Statement of Response to Pre-Application Consultation Opinion

Strategic Housing Development

Dolcain House, Monastery Road, Clondalkin, Dublin 22

January 2022

Figure 1 – Proposed Site Layout Plan Option A – Including footpath

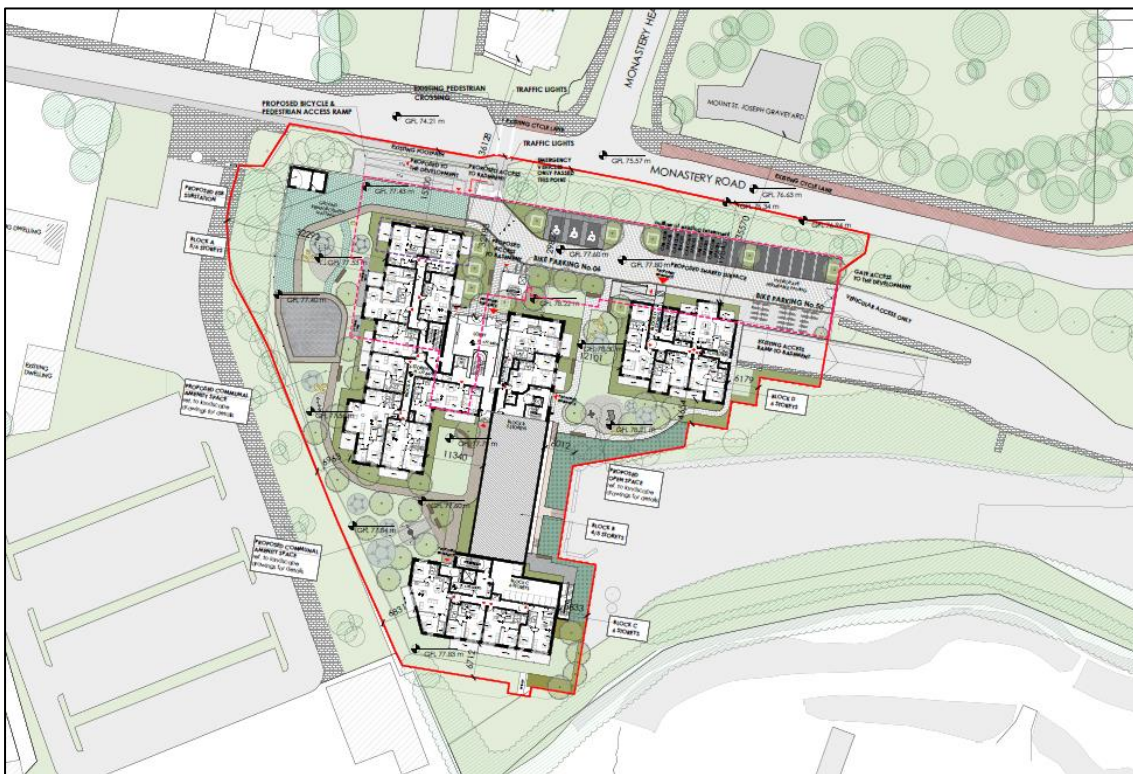
Further consideration of the documents as they relate to pedestrian and cycle access to/from the proposed development is required, in particular how the nature of this access/movement may alter as a result of the change of use from 'employment' to residential use. Consideration should include recognition of desire lines to public transport connections, particularly the Red Cow Luas stop to the east. As part of this, a pedestrian/cycle movement safety audit which would provide details of the scale of pedestrian movement associated with the existing office use, compared to that anticipated with the proposed residential use; along with a description of pedestrian and cycle routes from the site to surrounding areas; as well as any mitigation measures to ensure safe access and egress to the site for pedestrians and cyclists would assist, and demonstrate that these issues have been integrated in to the design of the scheme. Further consideration may require an amendment to the documents and/or design proposals submitted.

as a result of the change of use from 'employment' to residential use. Consideration should include recognition of desire lines to public transport connections, particularly the Red Cow Luas stop to the east. As part of this, a pedestrian/cycle movement safety audit which would provide details of the scale of pedestrian movement associated with the existing office use, compared to that anticipated with the proposed residential use; along with a description of pedestrian and cycle routes from the site to surrounding areas; as well as any mitigation measures to ensure safe access and egress to the site for pedestrians and cyclists would assist, and demonstrate that these issues have been integrated in to the design of the scheme. Further consideration may require an amendment to the documents and/or design proposals submitted.

The proposed development being submitted to the Board provides for 2 no. options. Option A provides for a footpath along the southern side of Monastery Road on the lands within the control of the applicant. The applicant does not have any legal interest in the adjoining third party lands and accordingly can only provide the footpath within their legal ownership. The second option (Option B) provides for the omission of the footpath at this stage noting safety concerns arising from the Pedestrian and Safety Audit with the applicant willing to accept a condition requiring the land to be reserved for the provision of a footpath and contribution towards same, which will be constructed when the adjoining third party lands are developed. The 2 no. options are being proposed in light of discussions with South Dublin County Council who indicated that their preference would be to provide a footpath, with their preferred option to be the provision of a footpath through the subject lands to the south of the existing hedgeline to the roundabout to the east. This path predominantly traverses third party lands and accordingly is beyond the remit of the applicant who does not have legal right to propose or construct a path on these lands. The applicant is therefore proposing a footpath along Monastery Road (which would connect to the footpath permitted under SD10A/0064 when these lands are developed). However, it is noted that the adjoining lands have not yet been developed and until such time that the lands are developed by a third party or by South Dublin County Council, the provision of a footpath as proposed in Option A would result in a footpath abruptly ending with potential pedestrian safety issues. This was confirmed in a Movement Safety Audit which is enclosed with this application. Therefore, Option B is being proposed which does not provide for a footpath. The applicant wishes to confirm to the Board that there is no objection to a condition requiring the reservation of these lands for a footpath to be provided in the future in conjunction with footpaths on the adjoining lands. The 2 no. options are submitted for the consideration of the Board and are discussed further below in this response.

Accordingly, the applicant sought to propose a 2m wide footpath on lands within their ownership to the south of Monastery Road (Proposed Site Layout Plan Option A as set out in Figure 1 above). This footpath would also tie in with the footpath as permitted under Reg. Ref. SD10A/0064 which is a current live permission set to expire on 9th November 2022 as illustrated in figure 6 below.

Figure 4 – Location of footpath as requested by South Dublin County Council

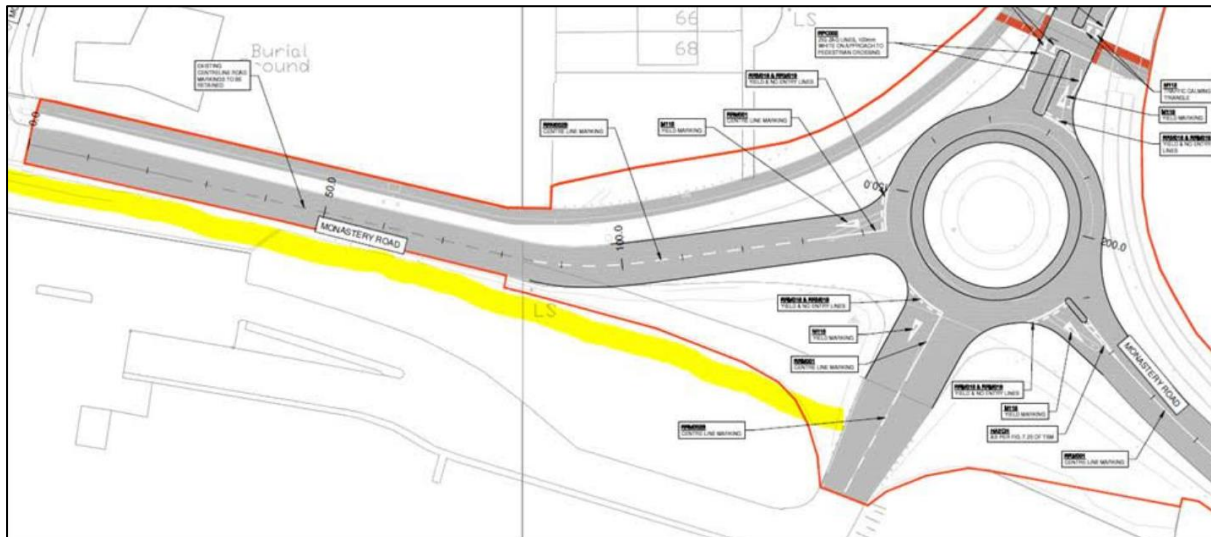
In email correspondence dated 7th December 2021, the Roads Department reverted recommending that a 2.0m wide footpath to the south of the existing trees and hedgeline to the roundabout should be provided. The following was noted in the email correspondence:

“The SDCC Roads Department recommend that the developer at Dolcain House, Monastery Road, Clondalkin, should accommodate a 2.0 meter wide path to accommodate pedestrians and cyclist at the northern boundary along the Monastery Road, recommended path for pedestrians/cyclist route is marked as yellow and shown in the attached drawing for your consideration.”

Just to clarify that the proposed path should run to the south of the trees and hedgeline. The purpose is to preserve the trees. The extent of the proposed footpath is from the proposed pedestrian entrance to the north of your proposed development with ramps for disability access down to the public road footpath on Monastery road. The footpath should be constructed eastwards inside the trees on your land and extending to the boundary line in red. There is a section on third party land in the middle. At the red line is where the SDCC public realm starts. It is SDCC's intention to extend this footpath further eastwards and connect to the existing footpaths on Monastery road to the east of the roundabout. Two Pedestrian crossings to be constructed. One across the SIAC access road and one to cross the Monastery road to the east of the Roundabout to connect to existing paths."

The applicant wishes to confirm to the Board and to South Dublin County Council that the applicant would have no issue with providing a footpath to the east of the subject lands if they had the legal right to do so. However, the footpath to the east is predominantly on third party lands that are not in the ownership of the Council or of the applicant and therefore the applicant cannot provide or propose a footpath/cycle lane or any works on lands that they have no control over. It is outside the remit of the applicant to provide the footpath as set out in Figure 4 above. The extent of the third party ownership is outlined in dashed purple figure 5 below.
